APP-GW-GLR-045-NS, Revision 1  
"Nuclear Island: Evaluation of Critical Sections"  
Technical Report Number 57

**TITLE: Nuclear Island: Evaluation of Critical Sections**

## **Nuclear Island: Evaluation of Critical Sections**

The AP1000 design has been certified for application at a hard rock site. Seismic analyses of the AP1000 at soil sites are described in Reference 3. The design of Nuclear Island structures was reconciled, and if needed, updated to address the seismic analyses results of Reference 3.

Figure 3H.5-5 (Sheet 2 of 3)

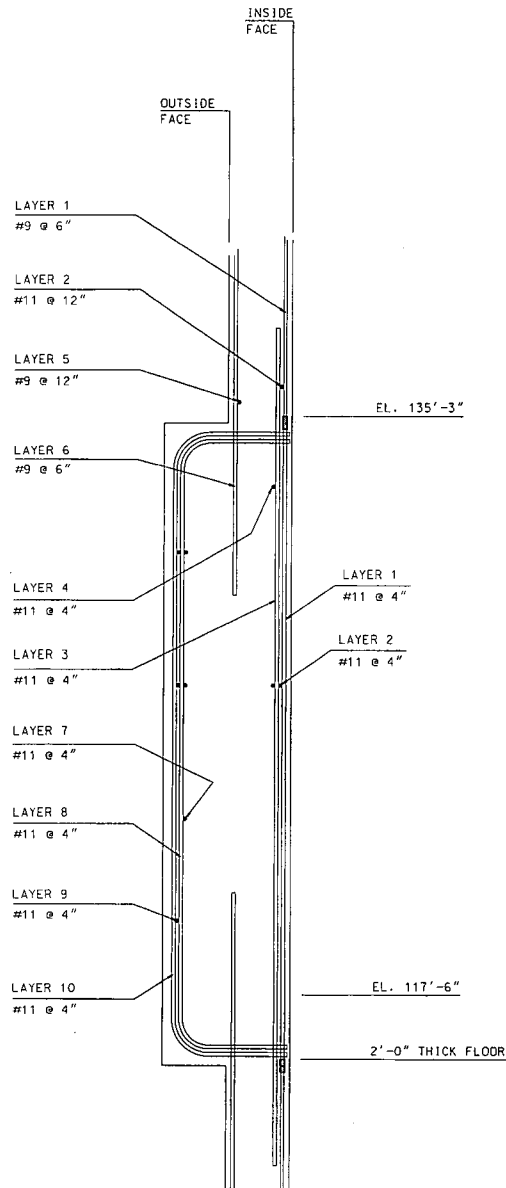
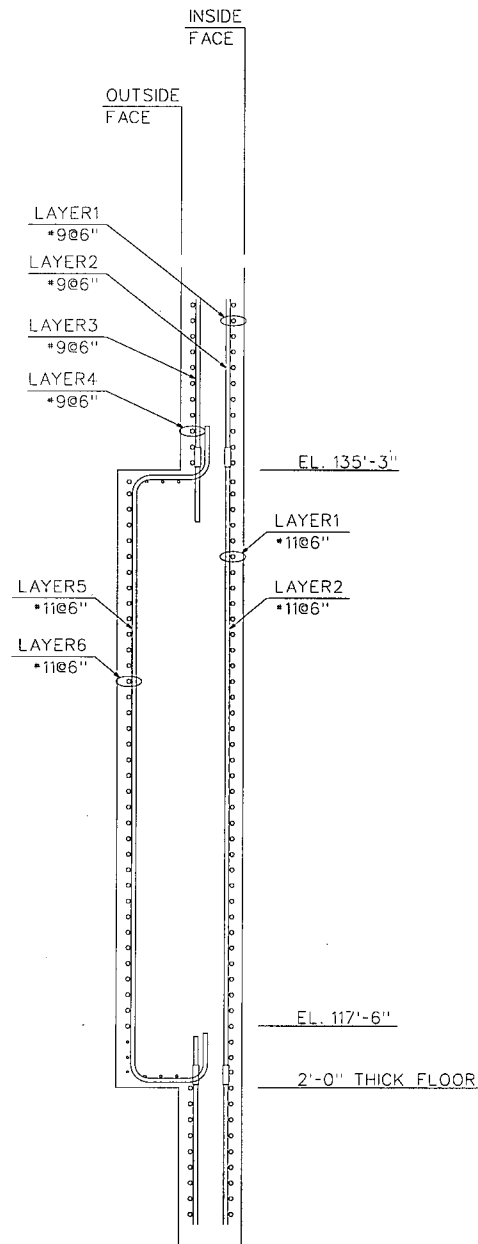
**Figure to be deleted**

**Figure to be inserted**

Figure 3H.5-5 (Sheet 3 of 3)

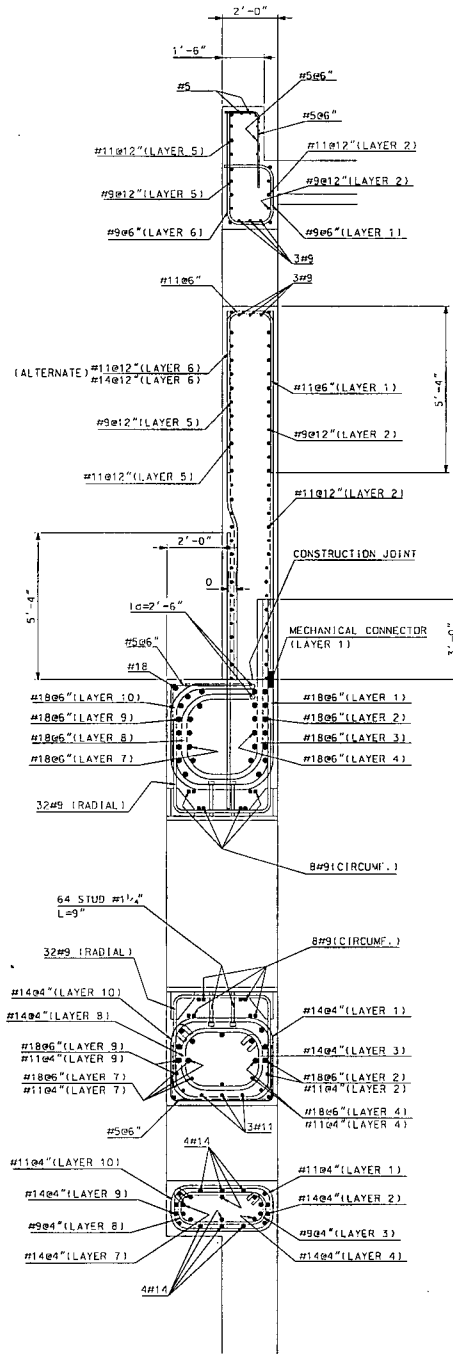
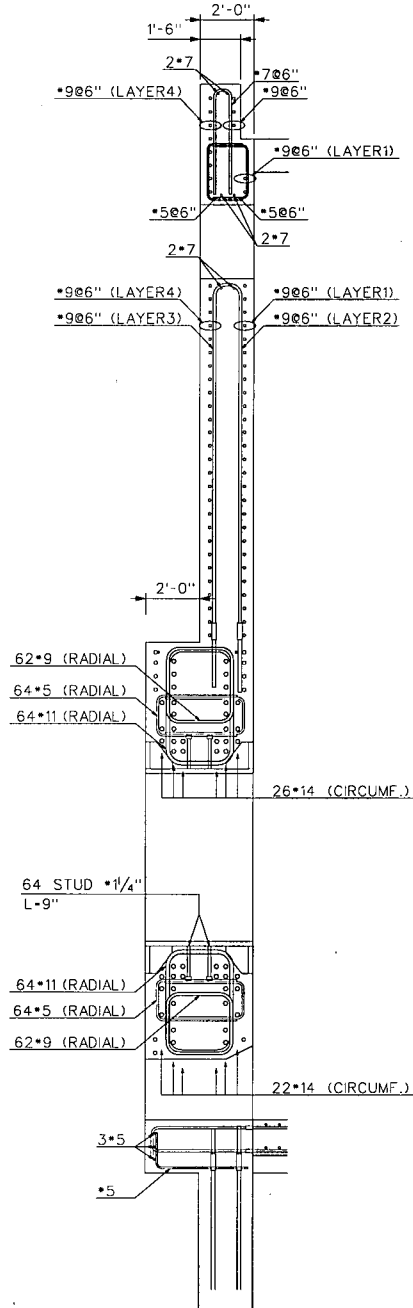
**Figure to be deleted**

**Figure to be inserted**

Figure 3H.5-6

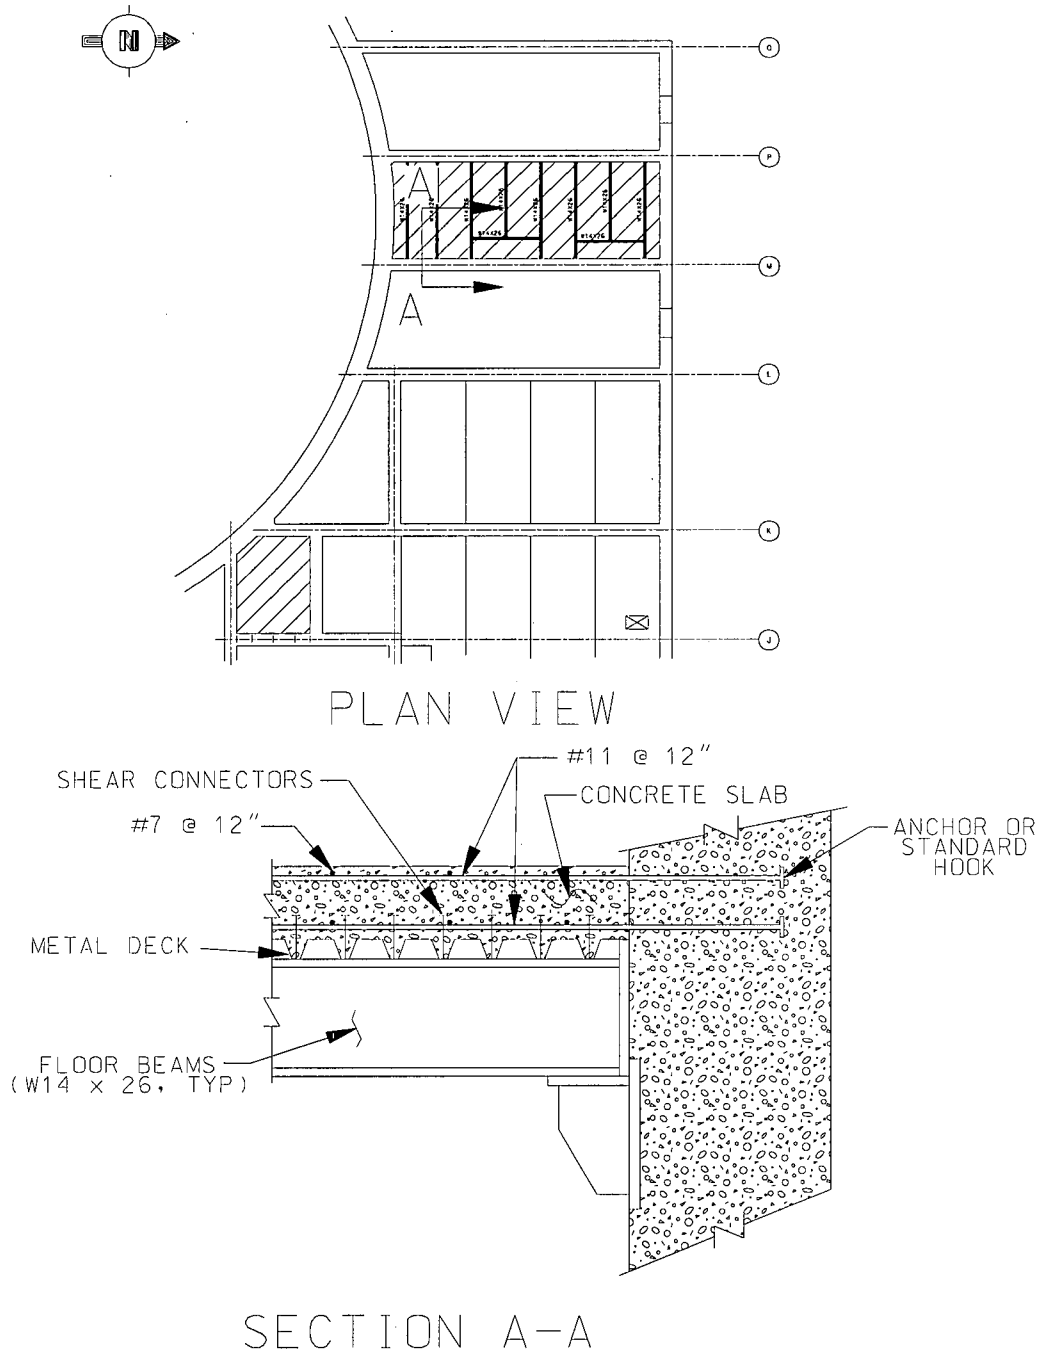
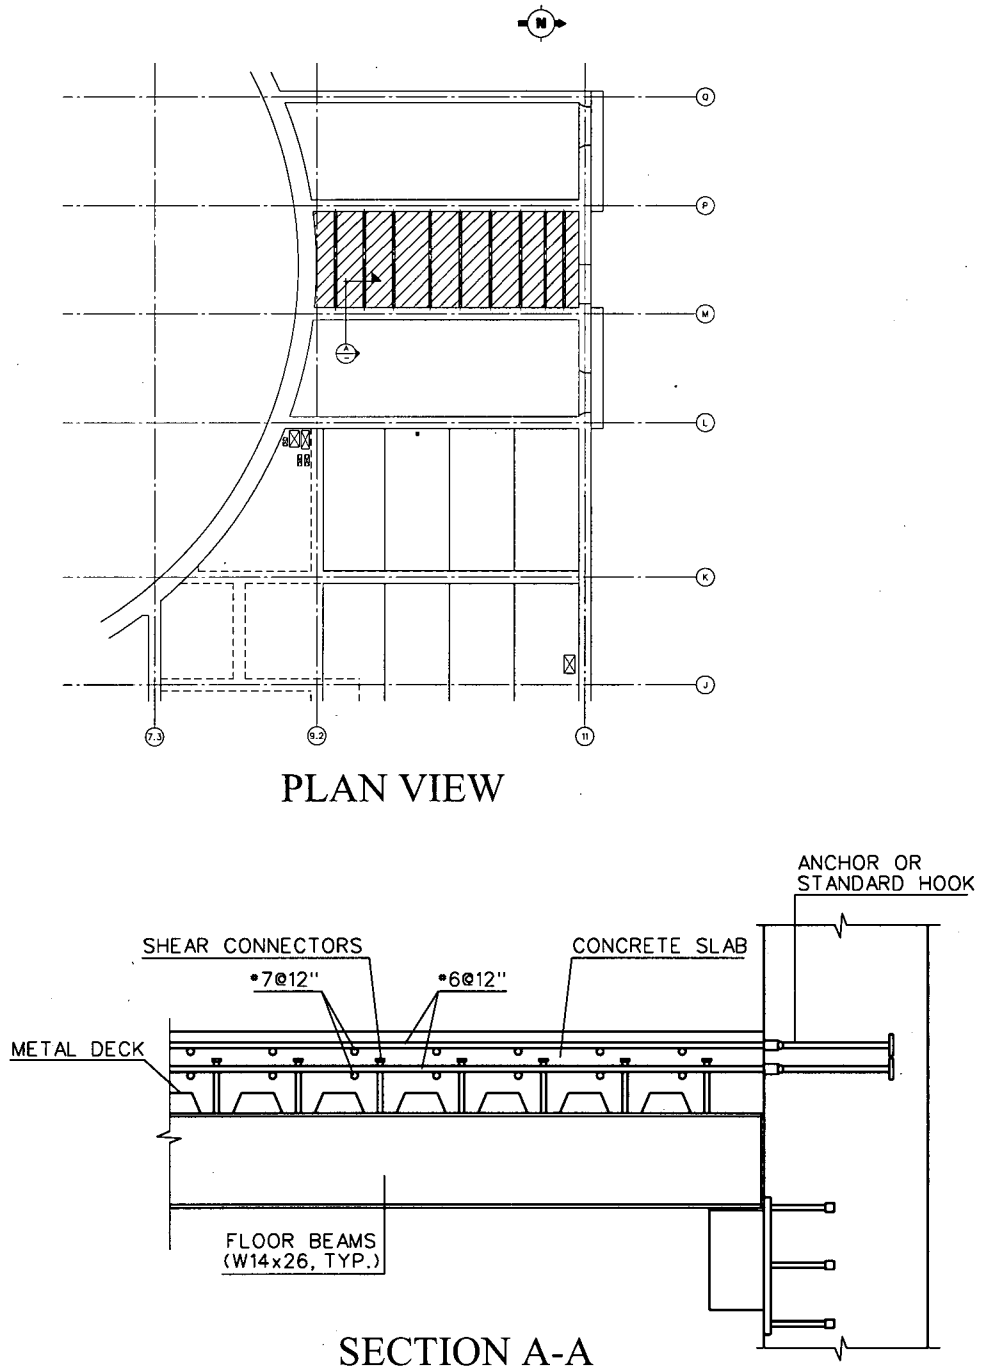
**Figure to be deleted**

**Figure to be inserted**

Figure 3H.5-8

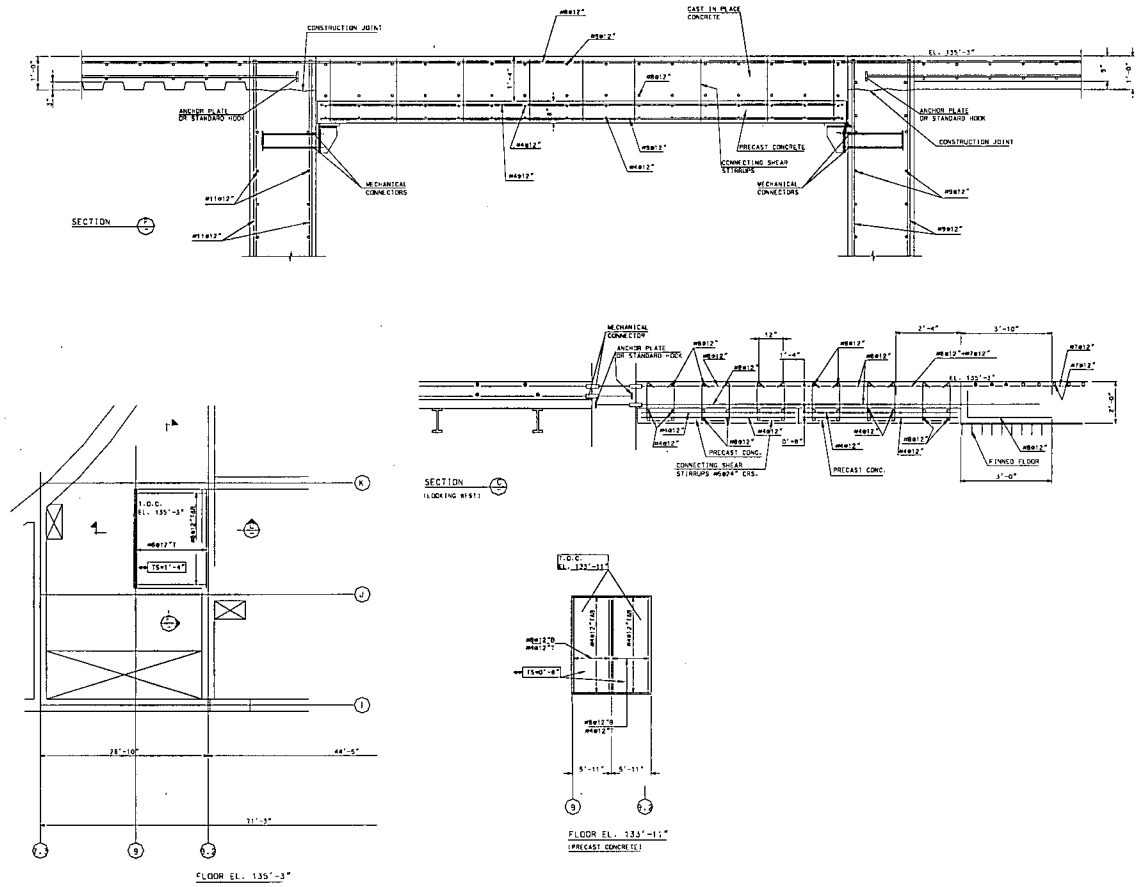
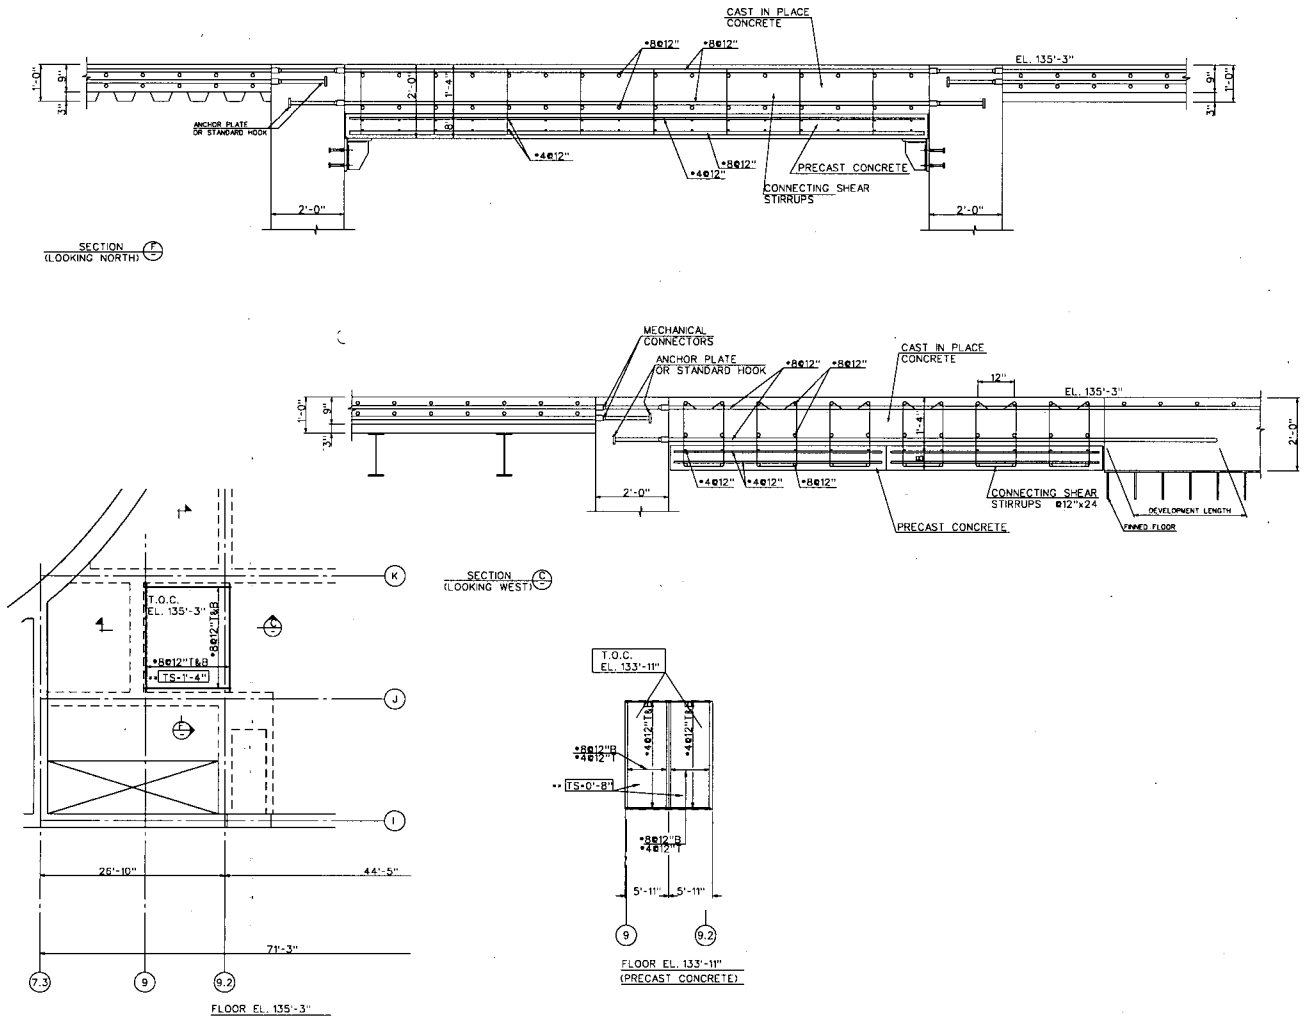
**Figure to be deleted**

**Figure to be Inserted**

Figure 3H.5-9 (Sheet 1 of 3)  
**[Auxiliary Building Finned Floor]\***

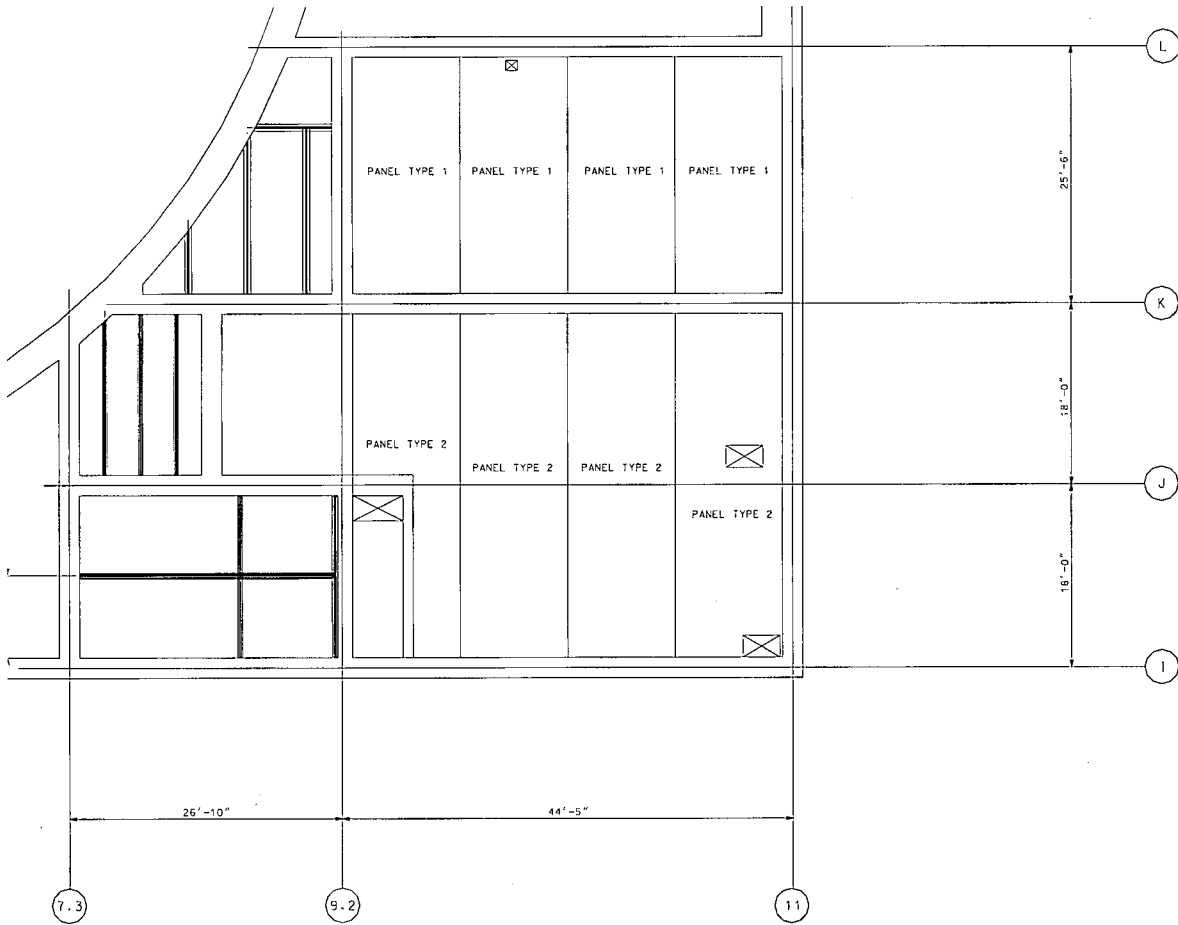
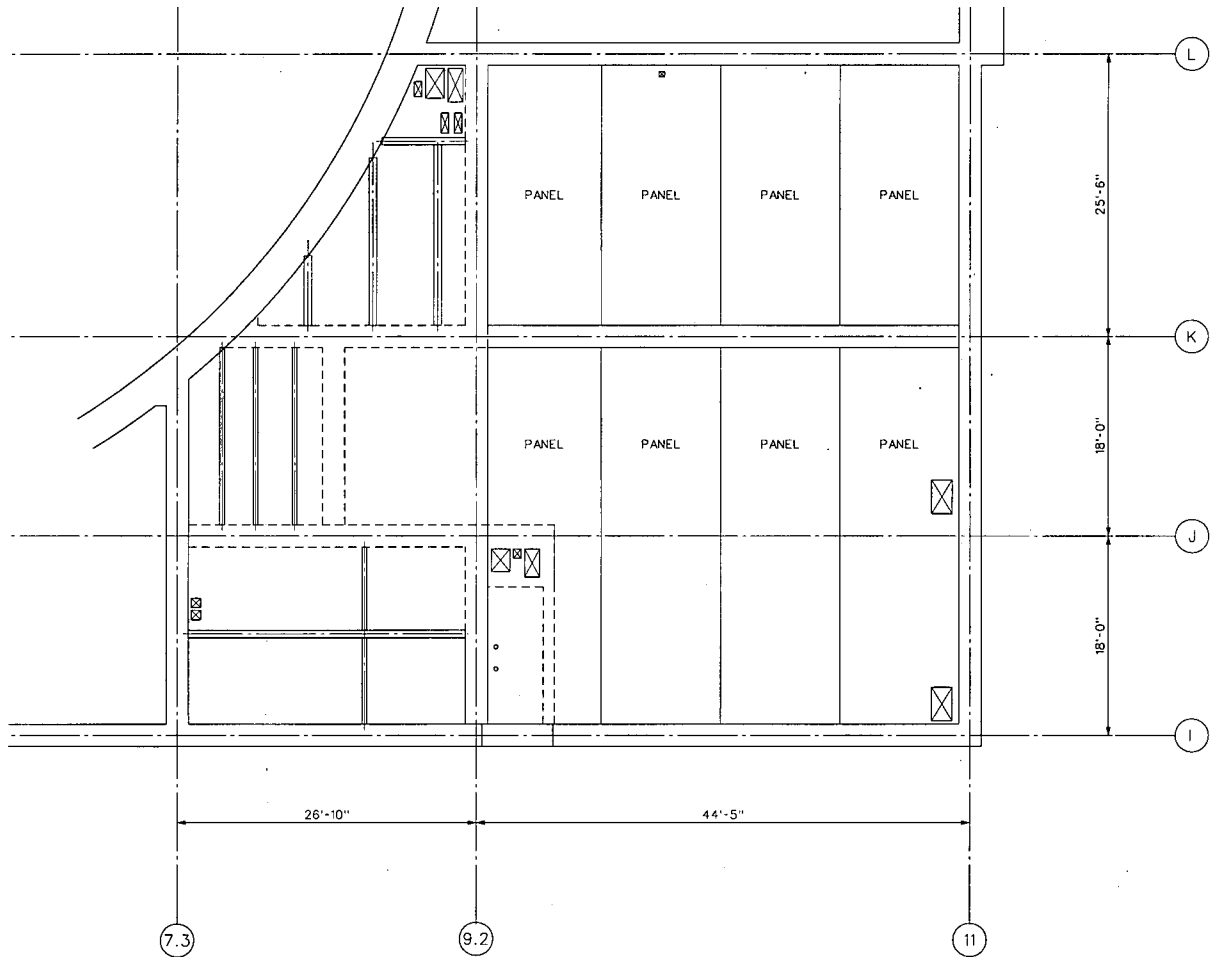
**Figure to be deleted**

**Figure to be inserted**
